Land Development Application LD-19-02, 3028 Raymond Avenue, Roslyn, PA 19001 - Joseph and Louise Dougherty

Consider a motion approving the Land Development Application for 3028 Raymond Avenue to extinguish an existing rain garden easement and rain garden and replace it with a new Stormwater easement and Stormwater dry well facility.

We have reviewed the submitted plans and report for the above referenced land development. The submitted information consists of a four (4) sheet plan set dated March 18, 2019 prepared by Eastern/Chadrow Associates, Inc. The Post-Construction Stormwater Management Narrative is dated November 28, 2018 and was also prepared by Eastern/Chadrow Associates, Inc.

SHEET 2 of 4

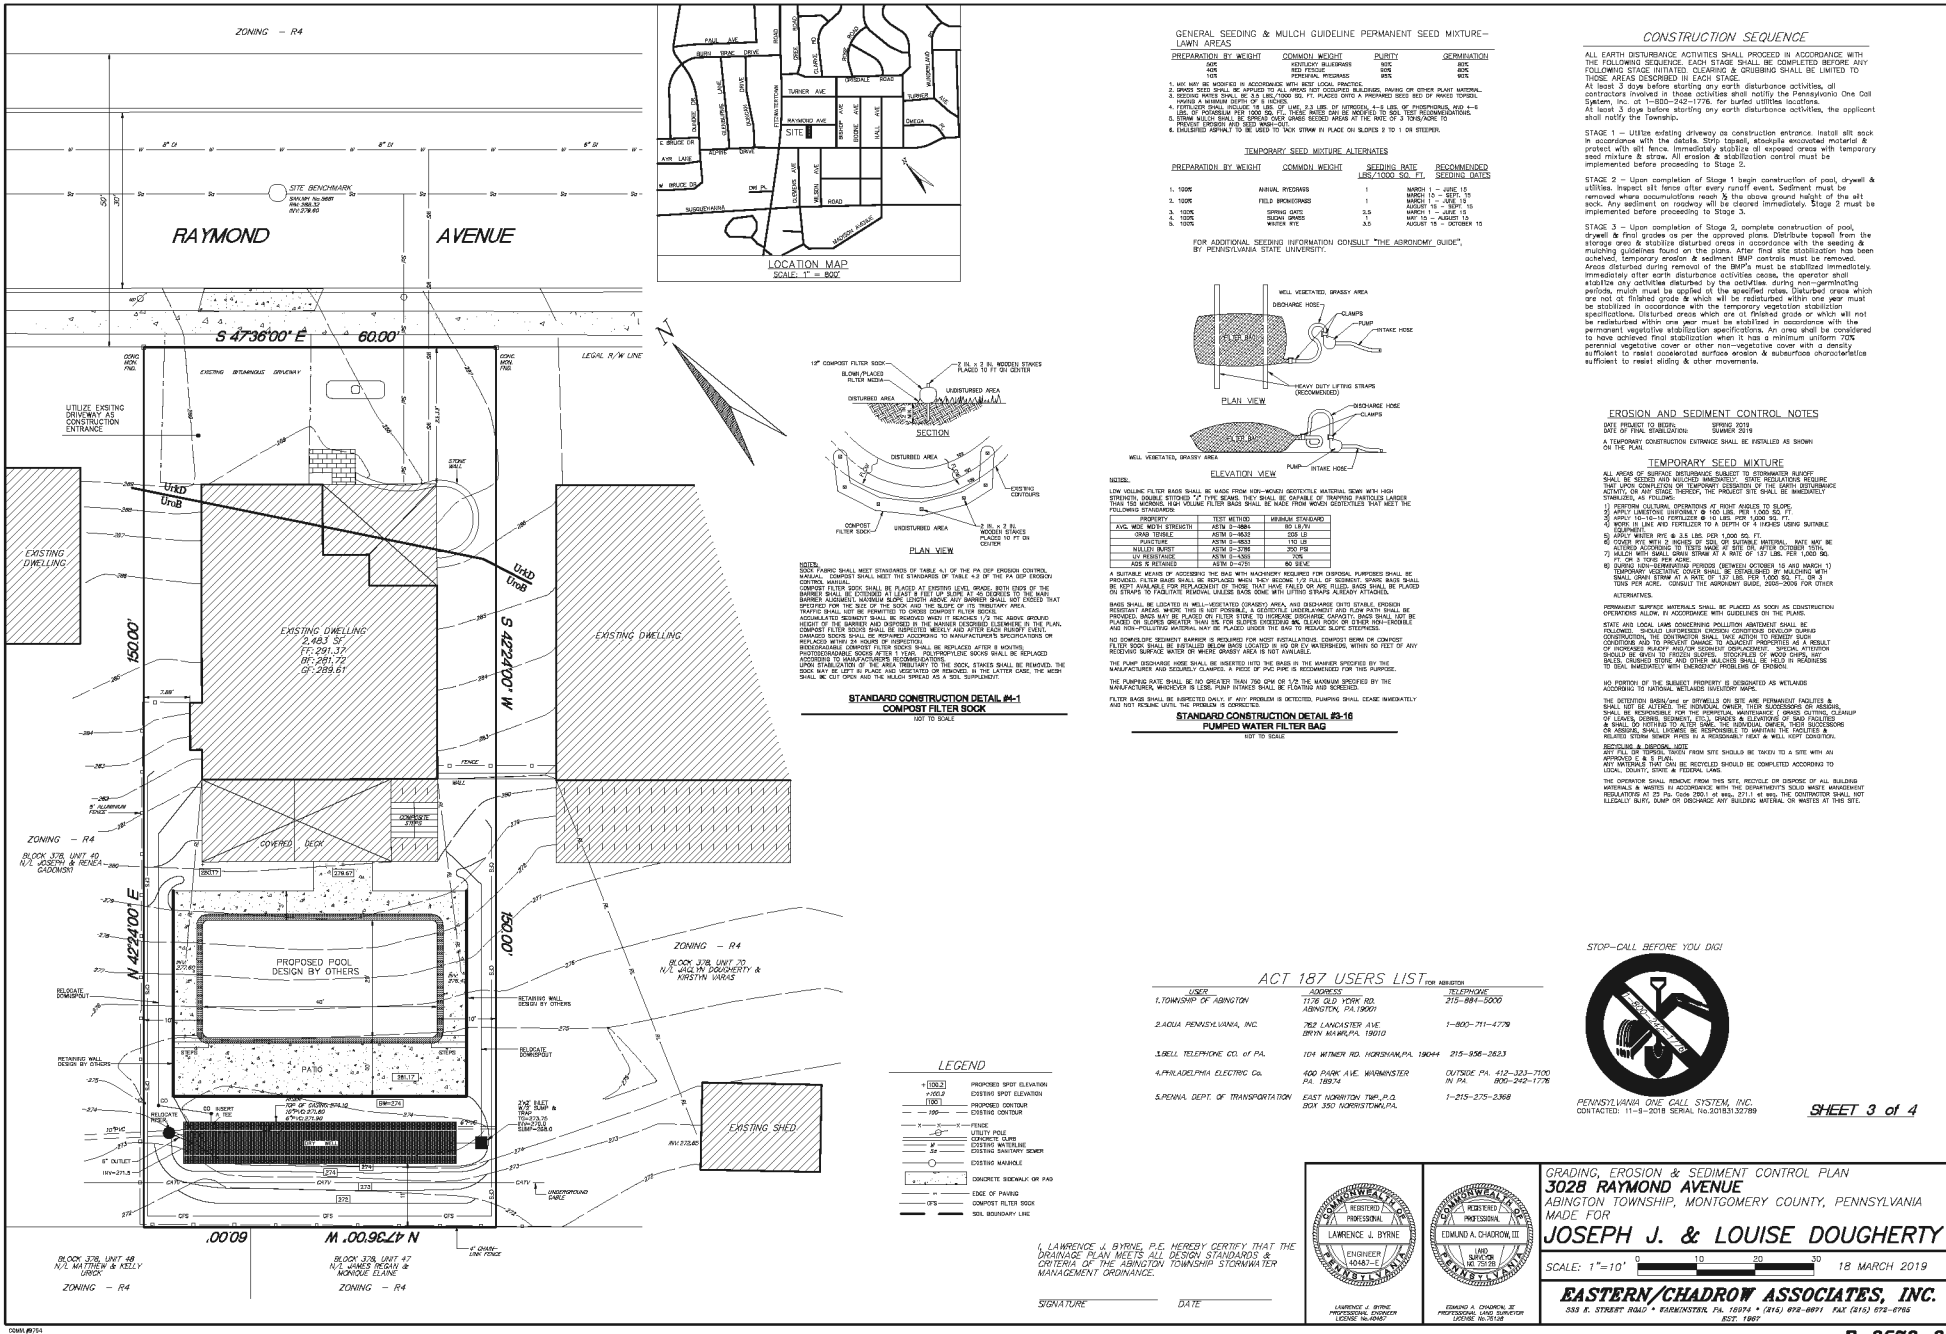
10. Sheet 3 contains a Pumped Water Filter Bag detail. It must be clarified as to where this is intended to be used or removed from the plan.
11. The existing rain leaders are shown to be under the pool decking. This portion of the leaders should be identified as "to be removed" on either this and/or the existing features plan.

SHEET 4 of 4

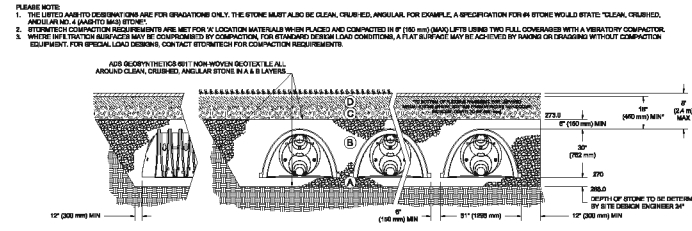
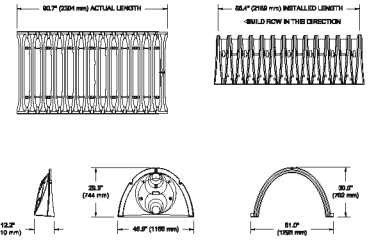
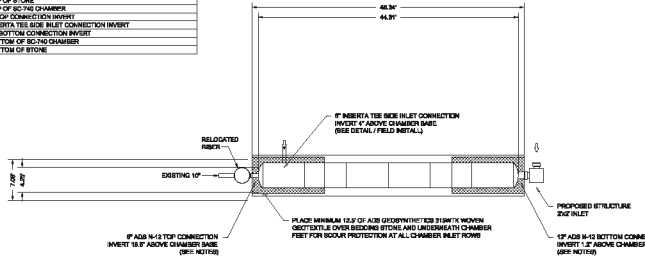
13. The existing riser is shown to be relocated. Proposed invert and top of riser elevations must be provided.
14. The stormwater management facility is labeled as a "dry well" on Sheet 3. The details on Sheet 4 should also be labeled as being for the "dry well".
